SEP 04 ZUIZ Form 3160-5 FORM APPROVED OCD Artesia OM B No 1004-0137 Expires. March 31, 2007 (April 2004) PARTMENT OF THE INTERIOR LAND MANAGEMENT 5. Lease Serial No. LC-061705B NM0506A SUNDRY NOTICES AND REPORTS ON WELLS If Indian, Allottee or Tribe Name Do not use this form for proposals to drill or to re-enter an abandoned well. Use Form 3160-3 (APD) for such proposals. 7. If Unit or CA/Agreement, Name and/or No. SUBMIT IN TRIPLICATE- Other instructions on reverse side. Poker Lake Unit NMNM71016X Type of Well

✓ Oil Well □ Gas Well□□ 8. Well Name and No. Poker Lake Unit #392H 2 Name of Operator BOPCO, L. P. API Well No. 30-015-40296 3a Address 3b Phone No. (include area code) 432-683-2277 P. O. Box 2760, Midland, TX 79702 10 Field and Pool, or Exploratory Area Poker Lake (Delaware) \_ -4. Location of Well-(Footage, Sec., T., R., M, or Survey Description) 11. County or Parish, State Surface: NWNE,UL C, 200' FNL,1900' FWL,Sec 20,T24S,R31E, Lat N32.209394, Long W103.801783 Bottom Hole: 750' FSL, 550' FWL, Sec. 21, T24S, R31E, Lat: N32.197503, Long: W103.788939 **Eddy County** 12. CHECK APPROPRIATE BOX(ES) TO INDICATE NATURE OF NOTICE, REPORT, OR OTHER DATA TYPE OF SUBMISSION TYPE OF

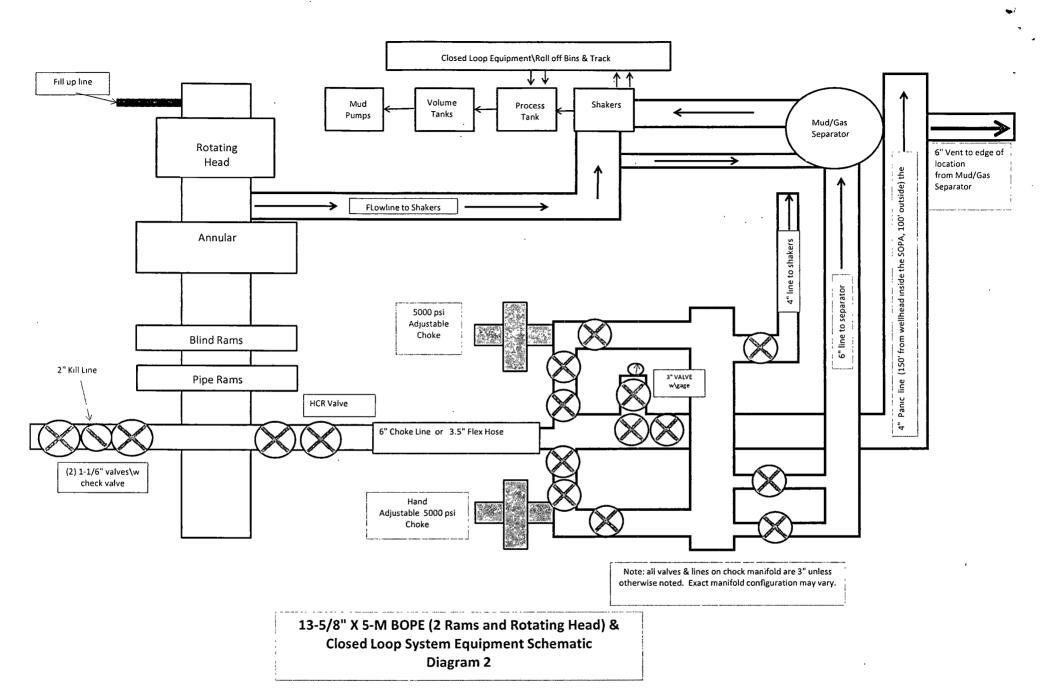
BOPCO, L.P. would like to utilize an armored, 3", 5000 psi WP flex hose for the choke line in the drilling of the well. This is rig equipment and will help quicken nipple up time thus saving money without a safety problem. The hose itself is rated to 5000 psi and has 5000 psi flanges on each end. This well is to be drilled to 13,679' MD (8,143' TVD) and max surface pressure should be +/- 1,792 psi as prescribed in onshore order #2 shown as 0.22 psi/ft. Thus, 2000 psi BOPE (for 12-1/4" hole) and 3000 psi BOPE (for 8-3/4" and 6-1/8" hole) is all that is needed for this well.

The Latshaw #4 BOPE diagram (5000 psi as specified within the approved APD) is attached along with the Midwest Hose internal hydrostatic test report, test report chart, and manufacturer's anchor requirements.

The included Latshaw #4 BOPE diagram is also meant to replace the original Diagram 2 included in the approved APD.

Variance approved to use flex line from BOP to choke manifold. Check condition of flexible line from BOP to choke manifold, replace if exterior is damaged or if line fails test. Line to be as straight as possible with no hard bends and is to be anchored according to Manufacturer's requirements. The flexible hose can be exchanged with a hose of equal size and equal or greater pressure rating. Anchor requirements, specification sheet and hydrostatic pressure test certification matching the hose in service, to be onsite for review. If the BLM inspector questions the straightness of the hose, a BLM engineer will be contacted and will review in the field or via picture supplied by inspector to determine if changes are required (operator shall expect delays if this occurs).

## **Internal Hydrostatic Test Graph**

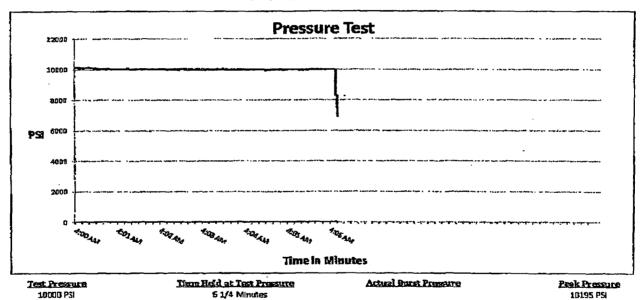
Comments: Hose assembly pressure tested with water at ambient temperature.
